SUBJECT: ISSUANCE OF AMENDMENT (TAC NO. M86361)

NORTHEAST NUCLEAR ENERGY COMPANY  
THE CONNECTICUT LIGHT AND POWER COMPANY  
THE WESTERN MASSACHUSETTS ELECTRIC COMPANY  
DOCKET NO. 50-336  
MILLSTONE NUCLEAR POWER STATION, UNIT NO. 2  
AMENDMENT TO FACILITY OPERATING LICENSE

Amendment No. 172  
License No. DPR-65

SAFETY EVALUATION BY THE OFFICE OF NUCLEAR REACTOR REGULATION

FIGURE 3.9-1A MINIMUM REQUIRED FUEL ASSEMBLY EXPOSURE AS A FUNCTION OF INITIAL ENRICHMENT TO PERMIT STORAGE IN REGION C

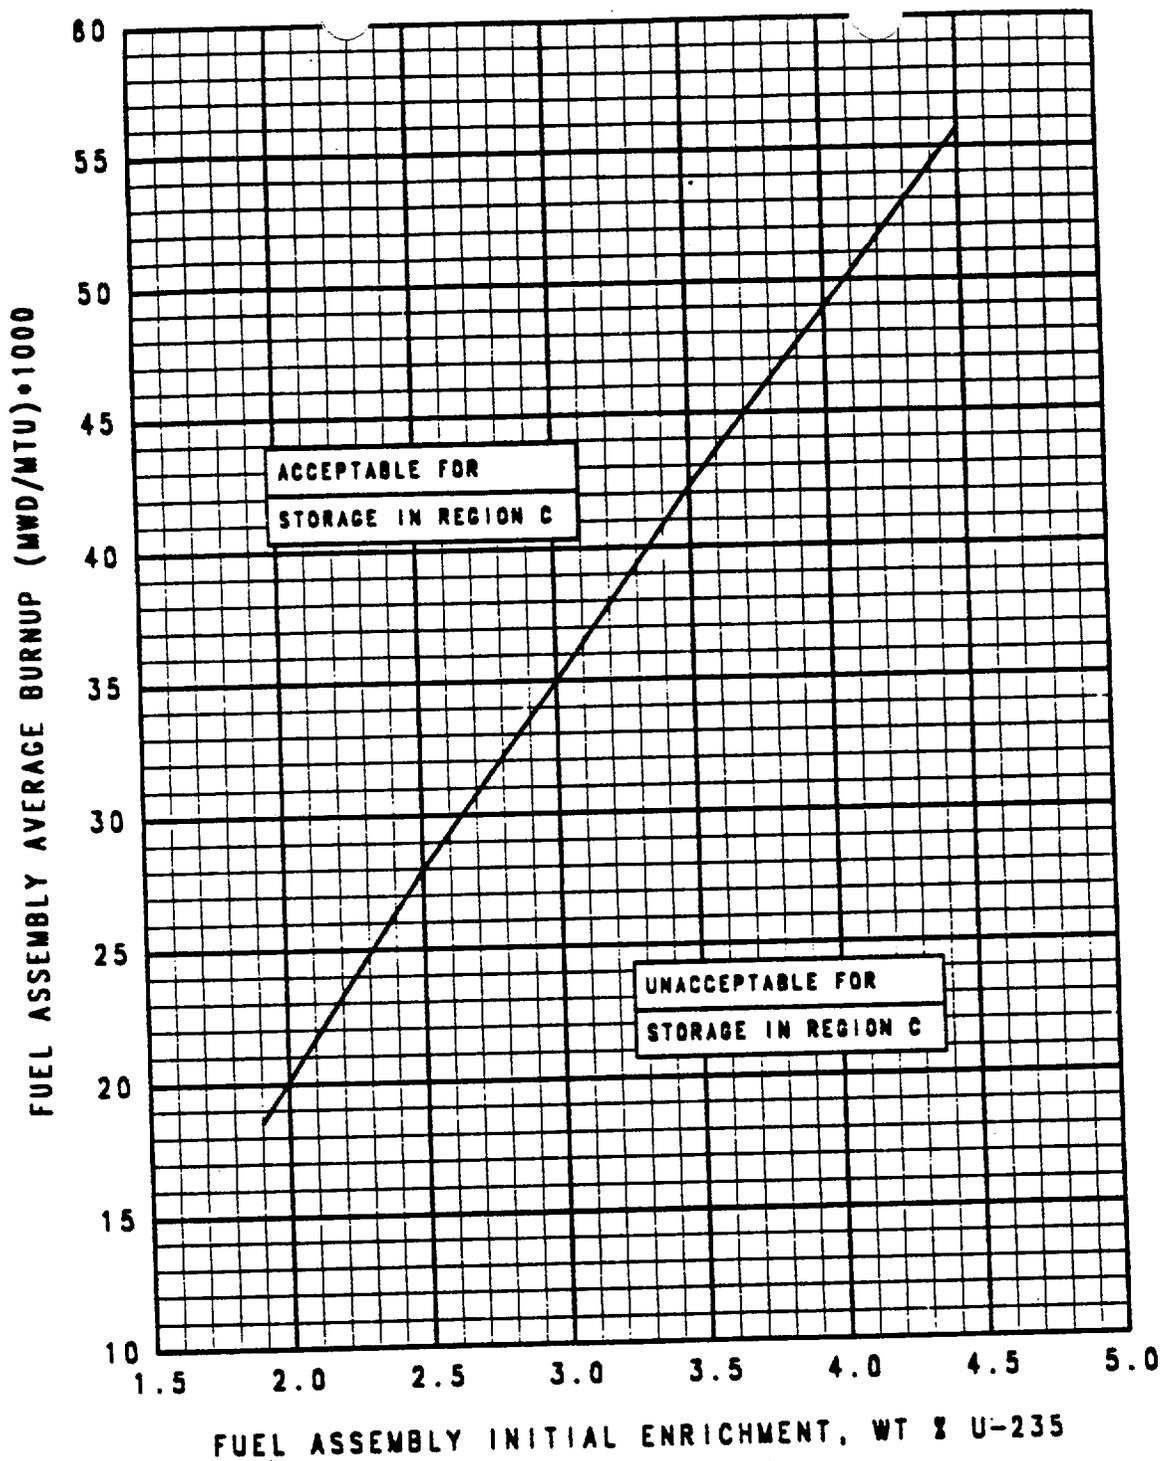
As seen in the curve of TS Figure 3.9-1B, fuel enriched to 4.5 w/o U-235 with poison rodlets require a minimum burnup of 44.26 MWD/KgU for storage in every cell location of Region C. In addition to the uncertainties considered above, uncertainties due to rodlet diameter and boron loading tolerances were also incorporated. The resulting maximum  $k_{eff}$  was 0.940, which meets the 0.95 criterion.

- (3) Figure 3.9-1 is being changed to Figure 3.9-1a, "Minimum Required Fuel Assembly Exposure as a Function of Initial Enrichment to Permit Storage in Region C," to reflect the revised burnups required of non-poisoned fuel assemblies for storage in Region C.

- (a) Fuel assembly enrichment and burnup are within the limits of Figure 3.9-1a by checking the assembly's design and burnup documentation; or
- (b) Fuel assembly enrichment and burnup are within the limits of Figure 3.9-1b by checking the assembly's design and burnup documentation, and borated stainless steel poison pins are installed in the assembly's center guide tube and in two diagonally opposite guide tubes.

FIGURE 3.9-1B MINIMUM REQUIRED FUEL ASSEMBLY EXPOSURE AS A FUNCTION OF INITIAL ENRICHMENT TO PERMIT STORAGE IN REGION C WITH POISON PINS INSTALLED

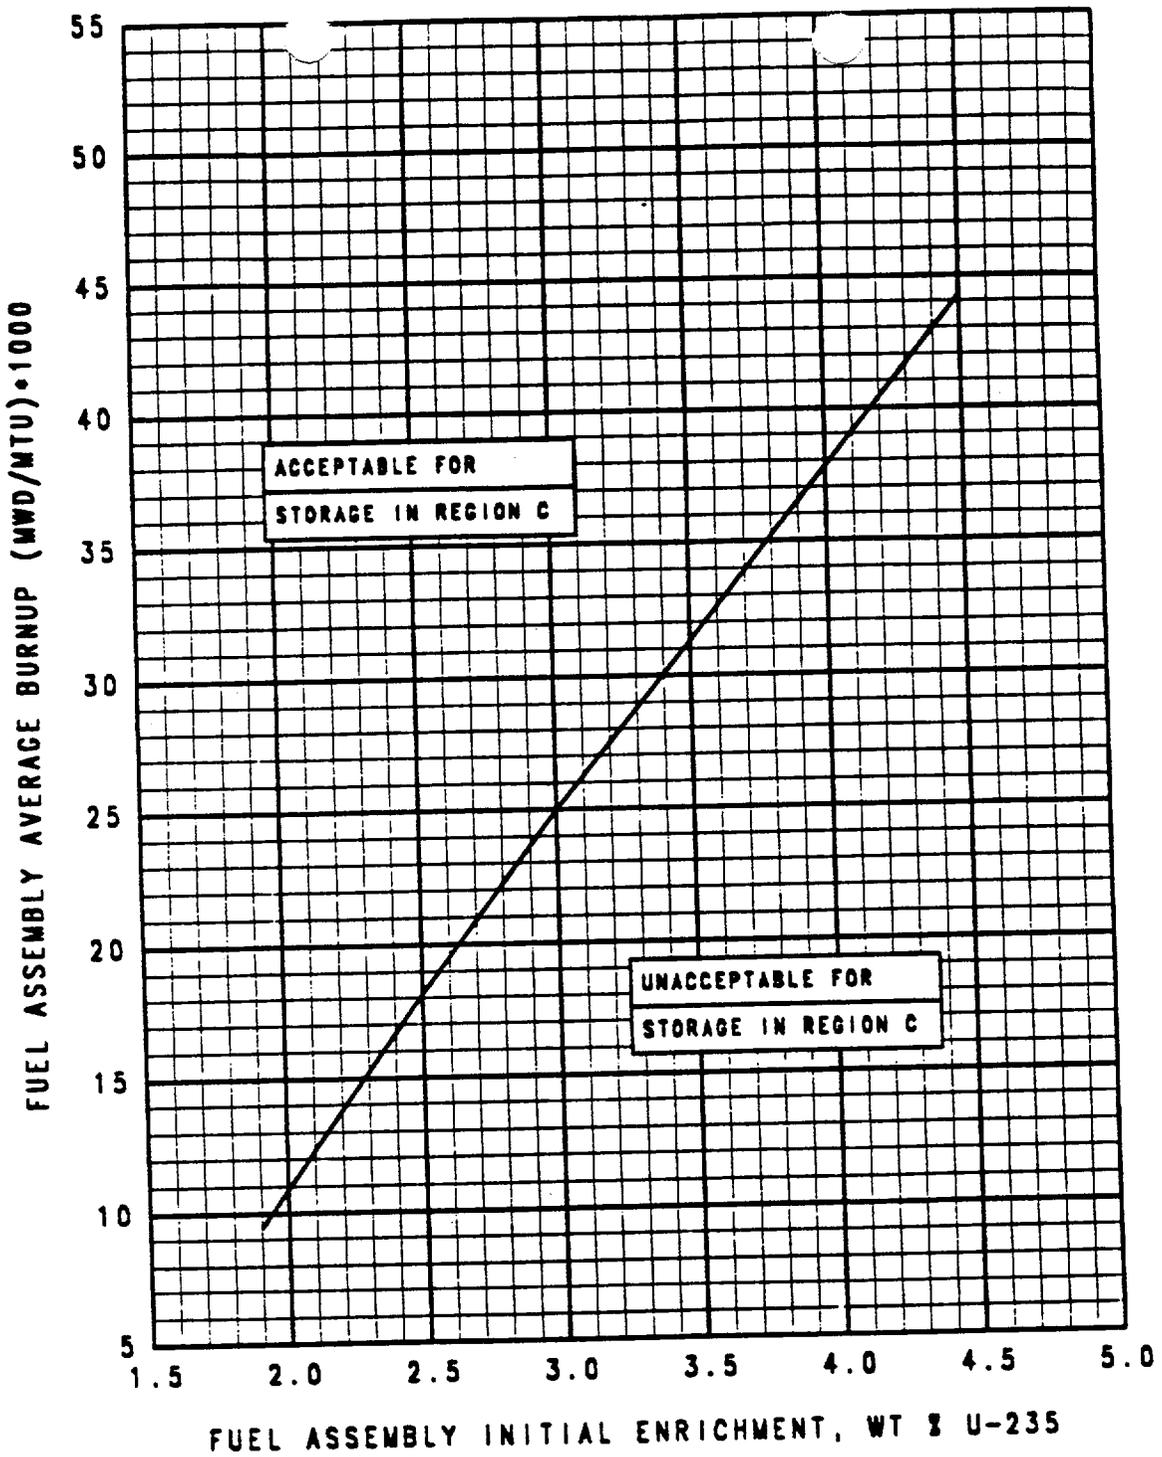
- (4) Figure 3.9-1b, "Minimum Required Fuel Assembly Exposure as a Function of Initial Enrichment to Permit Storage in Region C with Poison Pins Installed," is being added to reflect the burnups required of poisoned fuel assemblies for storage in Region C.

SPENT FUEL POOL ARRANGEMENT  
FIGURE 3.9-2

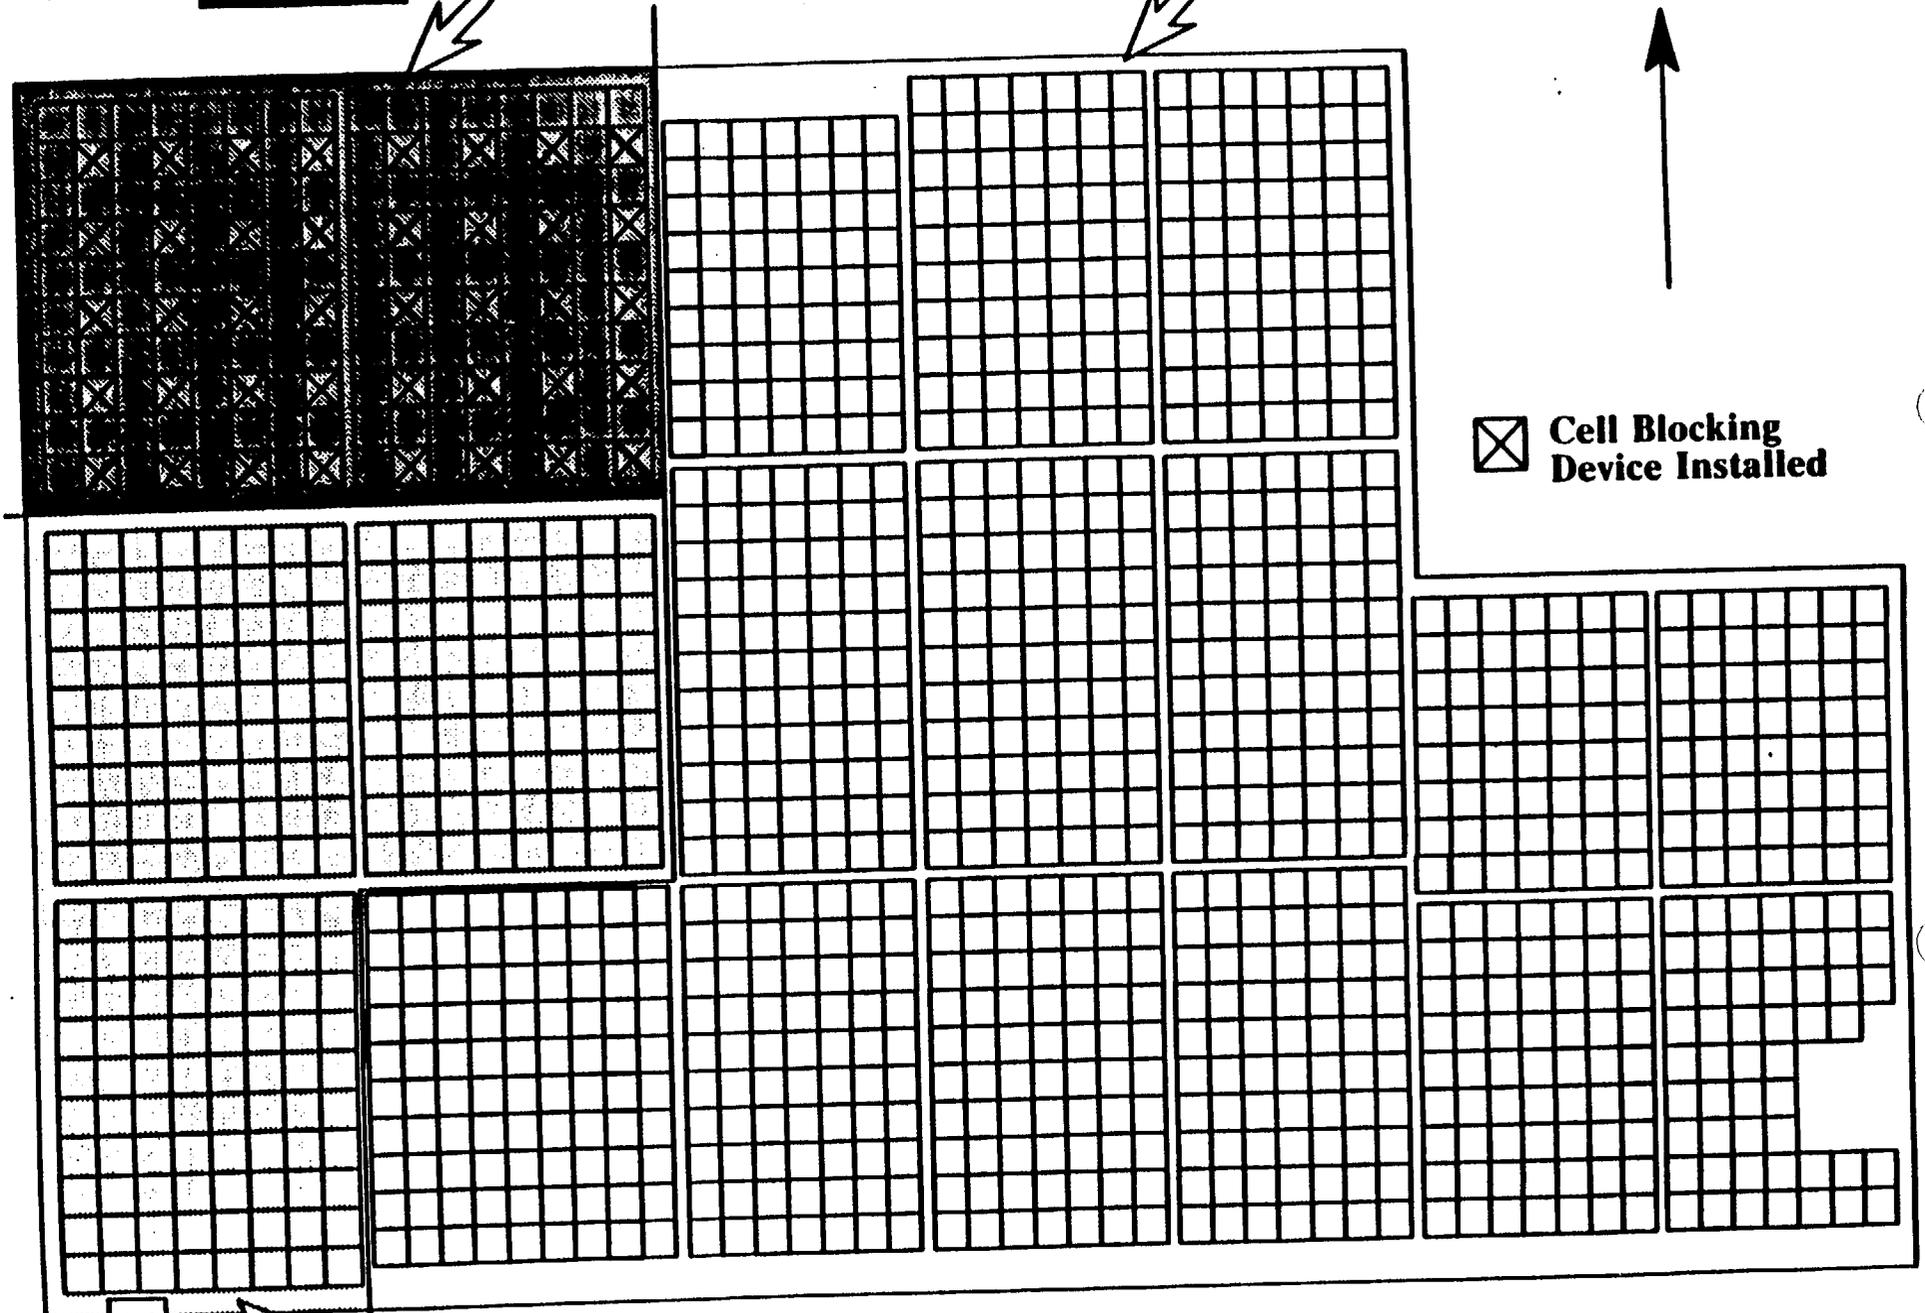
- (5) Figure 3.9-2 is being changed to remove the cell blocking devices previously required in Region C and to correct a typographical error in Region A.

- (1) A cell blocking device is installed in those cell locations shown in Figure 3.9-2; or
- (2) If a cell blocking device has been removed, all cells in the STORAGE PATTERN must be vacant of stored fuel assemblies.
